Westinghouse
Electric Company LLC

NRC-01-36

September 07, 2001

SUBJECT: CHANGED PAGES; LICENSE NUMBER SNM - 1107; DOCKET 70-1151

Figure 2.2

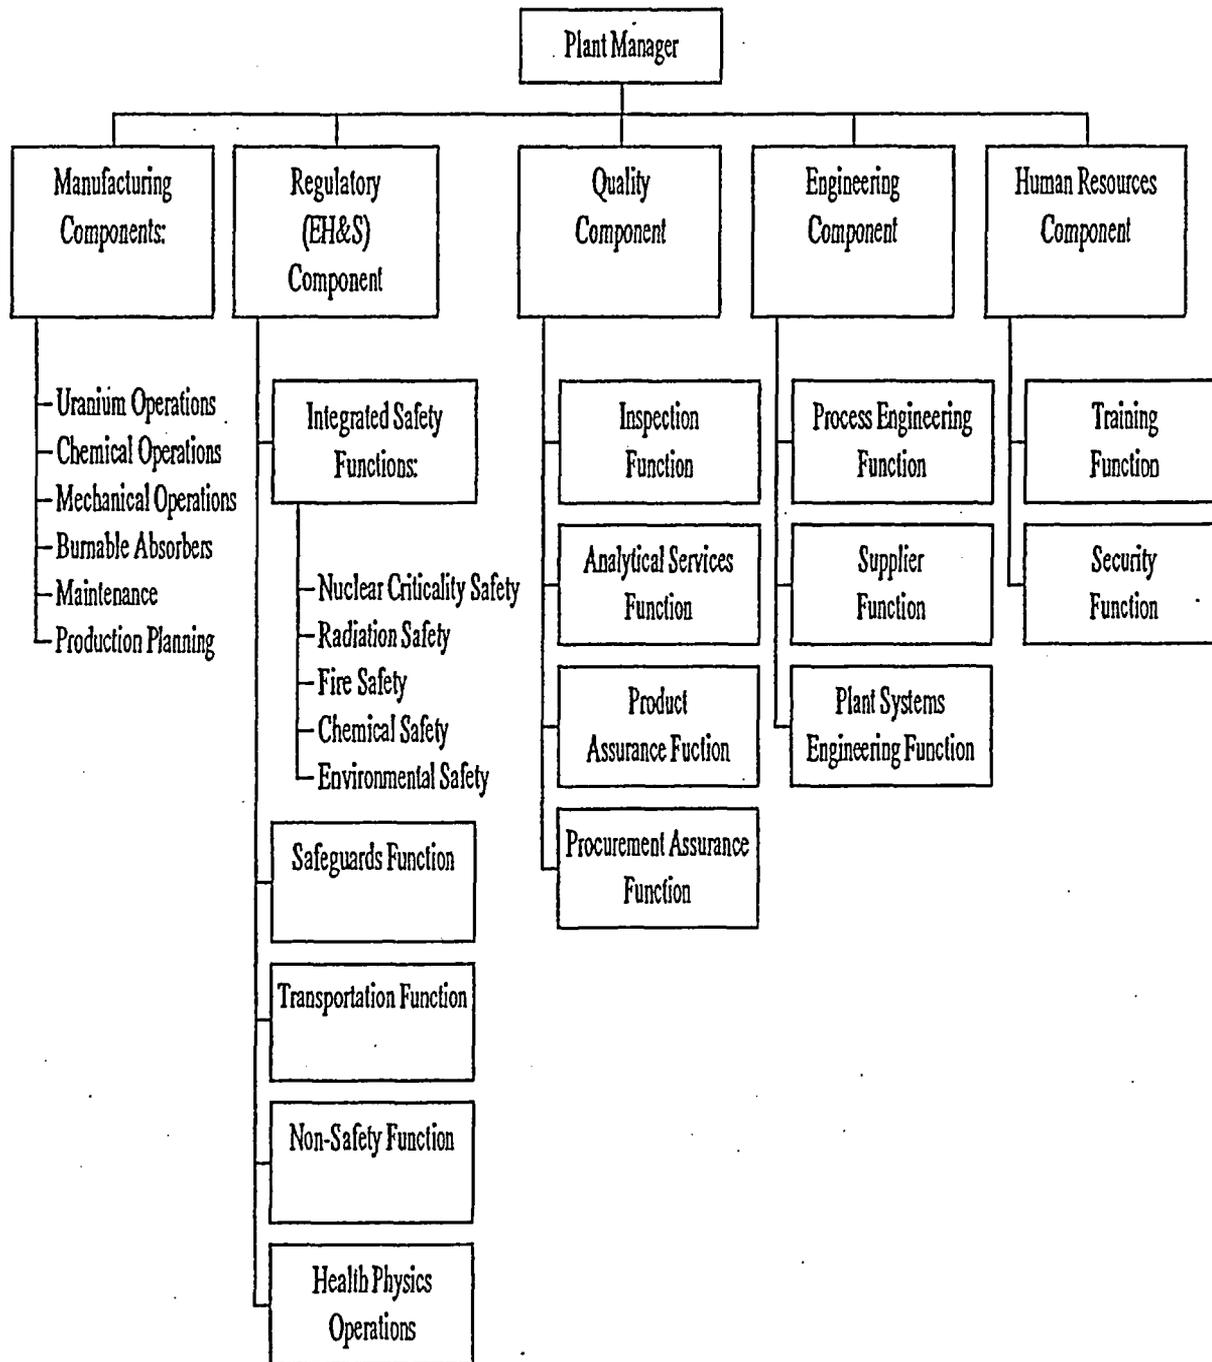
2. updated the organizational structure [page numbers 1.4, 1.5, 2.0, 2.2, 2.3, 2.5],
3. changed reference for additional corporate information to the worldwide web [page number 1.5],
